Memorandum

RE: **PZ 12-2020 The Residences at Hog Hollow (14001 Olive Blvd):** A request for a change in zoning from R-3 Residence District to PUD Planned Unit Development for a maximum of 100 residential units (16R340151).

Re: P.Z. 12-2020 The Residences at Hog Hollow, 14001 Olive Blvd., City of Chesterfield, MO -
Response Letter to Comments Dated 12/16/2020 (Stock Project No. 219-6568)

DRAWN BY: C.A.H.
 CHECKED BY: G.M.S.
 DATE: 10/30/20
 JOB NO: 219-6588
 DESIGNED BY: G.M.S.
 DATE: 10/30/20
 S.D.S. # 19MSD-16R
 S.L.C. # 16R
 M.A.N.R. # -
 M.O.R.A. # -
 SHEET TITLE:
 PRELIMINARY PLAN
 SHEET NO.: C1.0

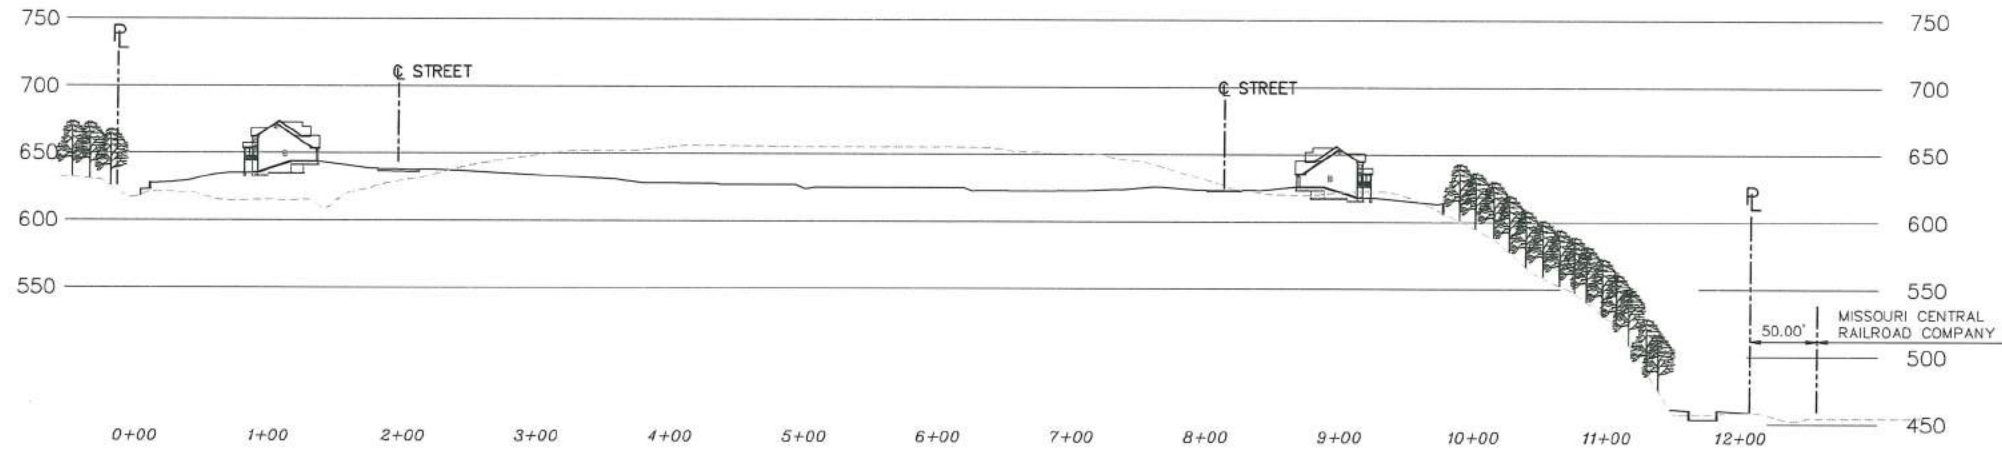
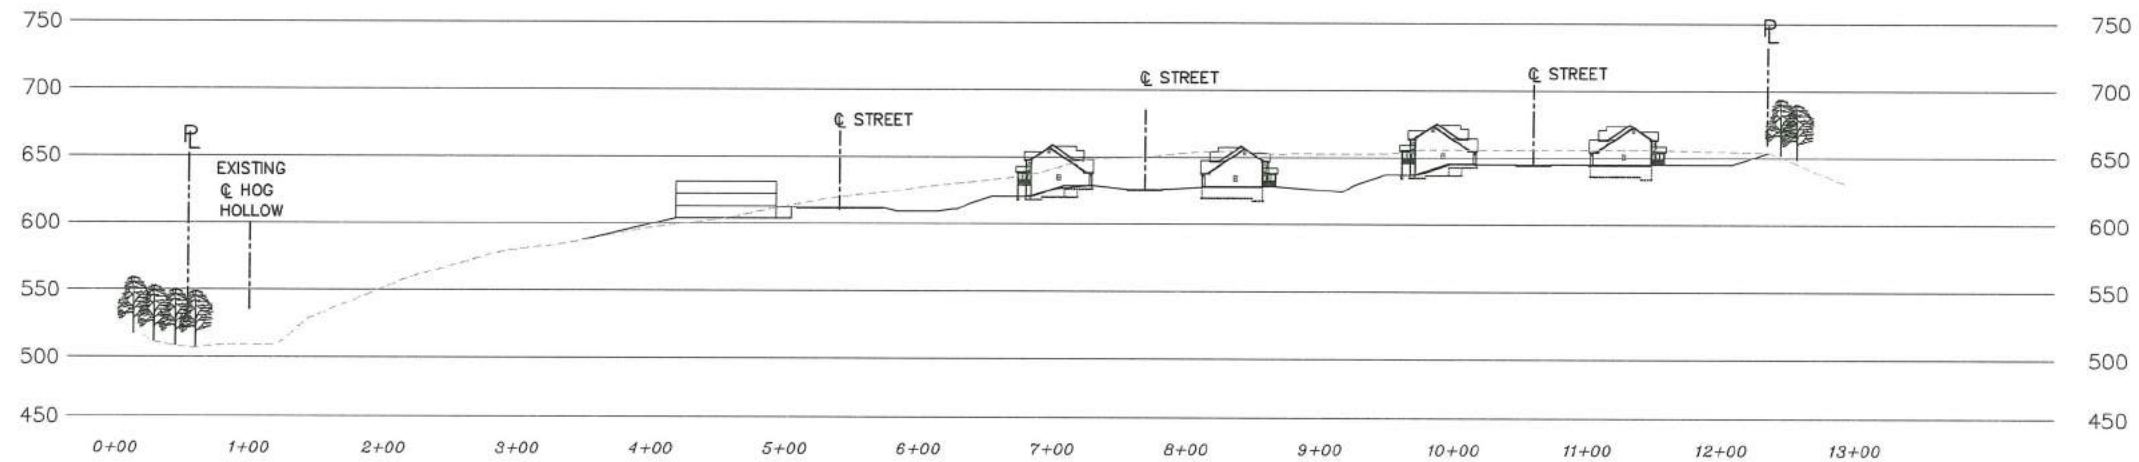
The applicant has provided updated trip generation figures. Per CBB, the peak number of “AM” trips is 15 vehicles in and 49 vehicles out. The peak number of “PM” trips is 53 vehicles in and 31 vehicles out. Additionally, the applicant reached out to the Missouri Department of Transportation (MoDOT) regarding the possibility of a three lane road leading into the development, to which MoDOT has no objection. The applicant has depicted a three lane road on the revised Preliminary Plan.

2. **Amenities:** There was discussion regarding the amenities displayed on the Preliminary Plan. While the Planning Commission appreciated the amenities shown on the Preliminary Plan, there was a question as to whether it would be possible to incorporate additional amenities throughout the site, rather than having the amenities concentrated at two ends of the site in the proposed pocket parks. Provide information pertaining to the potential for additional amenities.

3. **14015 Olive Boulevard:** There were several items discussed relating to 14015 Olive Boulevard.
 - Fencing: The property owner of 14015 Olive Boulevard requested a fence in order to screen his property from residents of the proposed development. In ensuing discussion, it was noted that there may be difficulties with sight distance should the fence be installed on the eastern boundary of 14015 Olive Boulevard, along the proposed entry road to the development. Provide information on the fence and depict on the Preliminary Plan.

2. Amenities: There was discussion regarding the amenities displayed on the Preliminary Plan. While the Planning Commission appreciated the amenities shown on the Preliminary Plan, there was a question as to whether it would be possible to incorporate additional amenities throughout the site, rather than having the amenities concentrated at two ends of the site in the proposed pocket parks. Provide information pertaining to the potential for additional amenities.

3. 14015 Olive Boulevard: There were several items discussed relating to 14015 Olive Boulevard:
 - a. Fencing: The property owner of 14015 Olive Boulevard requested a fence in order to screen his property from residents of the proposed development. In ensuing discussion, it was noted that there may be difficulties with sight distance should the fence be installed on the eastern boundary of 14015 Olive Boulevard, along the proposed entry road to the development. Provide information on the fence and depict on the Preliminary Plan.

The applicant responded that in order to provide sustainable and maintainable amenities, the ideal location for the proposed amenities is their current position on the Preliminary Plan. The amenities are made more safe and efficient by locating them within pocket parks that are visible from the street.

The applicant responded that the landscape buffer will be maintained by the future homeowners’ association in accordance with the Unified Development Code and a future approved Site Development Plan; The applicant noted that there is currently a chain link fence separating the two properties, and they have provided photos of the fencing with their response letter. The applicant does not have any objection to the property at 14015 Olive Boulevard installing a fence on their own property.

Response: In order to provide a sustainable & maintainable Amenity Package, it is most efficient & safe to locate those amenities within the designated Pocket Parks that are visible from street access.

Response: A sight proof fence is not a requirement of the 30-foot Landscape Buffer. The Landscape Buffer will be planted and maintained by the Home Owners Association in Accordance with City Code and an approved Site Development Plan. The Owner/Developer of the Residences at Hog Hollow is "Not Opposed" to the adjoining property owner (Keymer Reality & Investments, LLC) installing and maintaining a sight proof fence on their property, today a chain link fence exists between the two (2) properties (photos attached).
